**Flood Control Project Maintenance
Levee Inspections**

Maintenance Issue Types Only, Levee Inspection Report By Mile - Fall 2018

Sutter Maintenance Yard Maintenance Area 0001

Waterway	Bank	Unit Miles	Inspection Start/End	Inspector
Unit No. 01 Sacramento River	Right	16.76	10/04/2018 10/04/2018	Bob Duffey

Photo 1 of 3 : UCIP_FA_2018_51852_70064.jpg

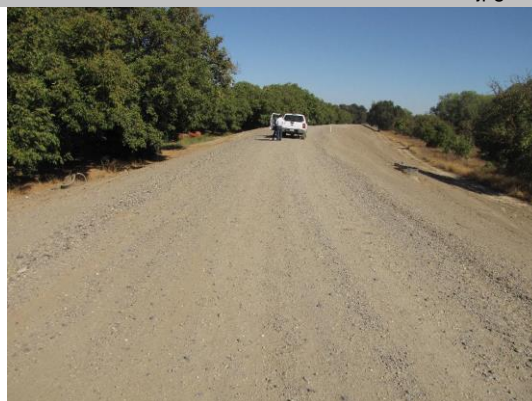
LM Start	1.92	Rating **	M	Issue No.	640	
LM End	1.92	Issue Type +	Ma	Location *		
Category	Supplemental			GPS Latitude/Longitude		
				Start	End	
Item	DWR UCIP LMA Responsibility			39.231866 °	39.231866 °	
				-122.015442 °	-122.015442 °	
DWR ID	16430

Comment Code						
Inspector Comment						
FS_ID:51852 DS_ID:16430 EP_NO: 9487 Repair Type: Non-Urgent Crossing Status: Found UCIP Comments: 5/3/2017 WS end still partially plugged. (DWR Sutter Yard- A Freitag)10/24/2016 Ws end is till partially plugged.(DWR Sutter Yard- A Freitag)4/25/2016 WS pipe end is still plugged with soil. Rest of the pipe appeared to be in good condition.4/20/2015 WS pipe end is plugged about 50% by soil.6/18/2014 Same as last inspection.12/17/2013 Same as last inspection.7/18/2013 WS pipe end has been reformed but is still clogged about 50% by sediment.10/18/2012 Remove dirt and debris in riser. Outlet deformed and blocked over 50%. Debris-round concrete section on landward side. This crossing was listed in the USACE Periodic Inspections as ID# USACE_CESPK_MA1C_2010_p_0116 for crossing outlet deformed and clogged with dirt. FIELD_STRUCT_DESC: 1 of 2: 36-inch corrugated metal drainage pipe through the levee, approximately 12-15 feet below the crown. Slide gates in corrugated metal pipe (CMP) riser located on the waterside (WS) slope. Pipe daylights on the landside (LS). (36-inch pipe [HLM 1.97] authorized under Automatic Board Order (ABO) issued as Permit No. 9487, 1974 - Jimeno Rancho) [Additional Reference(s): DWR Levee Log, 1992. USACE Sacramento O&M Manual 137, August 1955, (Station 103+18)]. FS Date: 5/19/2017 1:20:29 PM
